MEMORANDUM

TO Heritage Victoria FROM Lovell Chen
 RE P40433 – Request for further information DATE 22 May 2026

PROJECT
The AMIF - Stage 1

NAME
**Perspectives - From Convent
Garden - Nicholson St**

Figure 1 Undated drawings showing the original design proposed for the interwar verandah
 Source: Public Record Office Victoria, VPRS16127/P0003

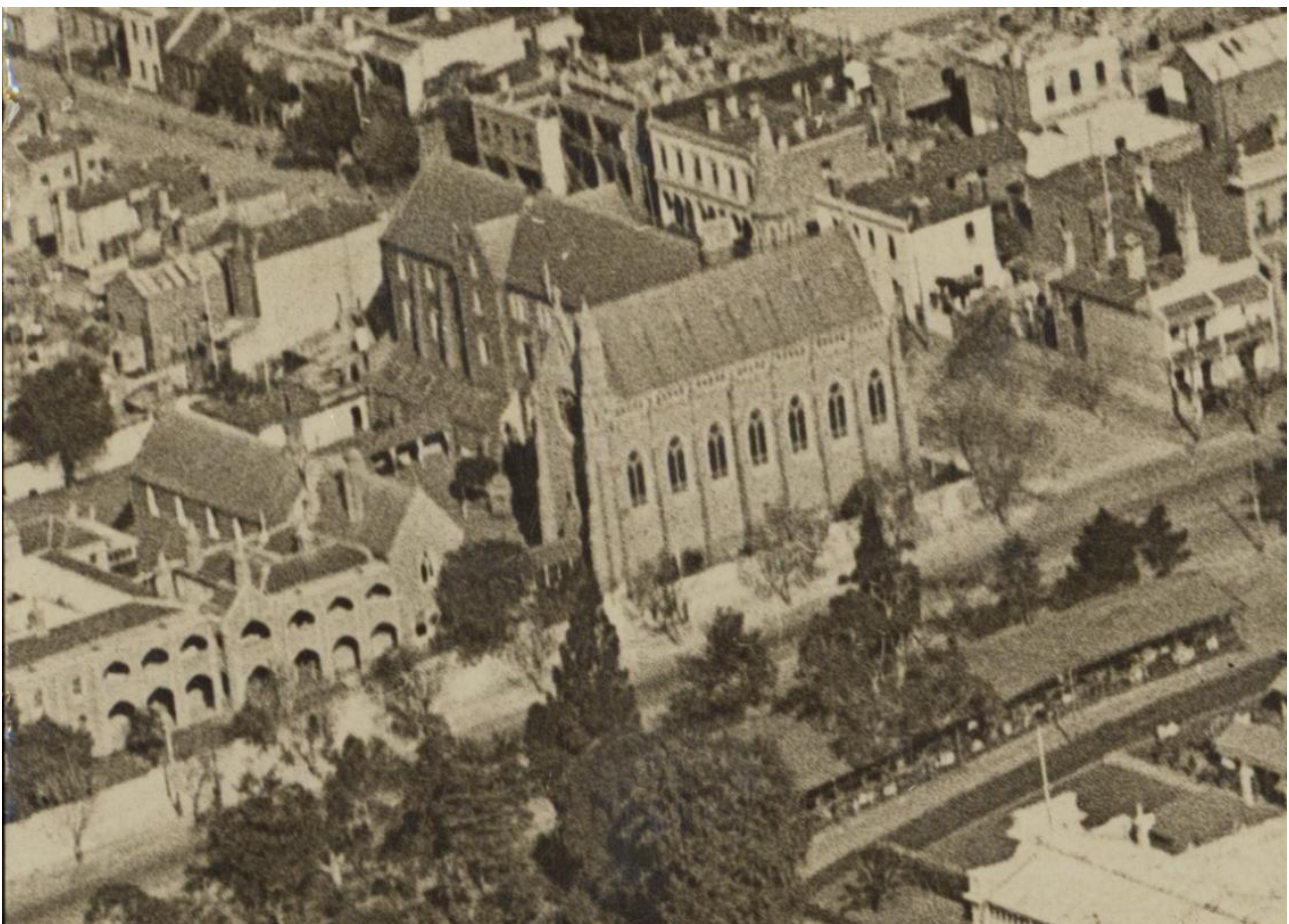
It is acknowledged that this element is a later addition. However, clarification is sought as to the necessity of widening the existing window openings. The justification provided—improved daylight and functionality to the 1850s Goold residence—is not clearly demonstrated.

As noted in the Heritage Impact Statement submitted with the application, the early construction of the Goold residence is already externally legible, and it is not evident that widening the openings is required to improve this understanding. Further, enlarging the openings to reflect early proportions risks confusing the historical arrangement, given these were historically window openings rather than doors. On this basis, retention of the existing verandah opening configuration is strongly preferred to avoid unnecessary change.

The proposal includes alterations to eight openings within the interwar verandah to the west elevation of the Goold and Kennedy residences. An undated drawing (Figure 1, likely 1920s) illustrates the original design intent for the verandah, comprising a series of seven segmental arched openings at ground and first-floor levels, with a central bay articulated by a curved parapet. At the northern end, the design included two sets of windows at each level with a gabled parapet above. This scheme appears to have been conceived to present a cohesive architectural presentation to Nicholson Street and to match the gabled end of Kennedy residence.
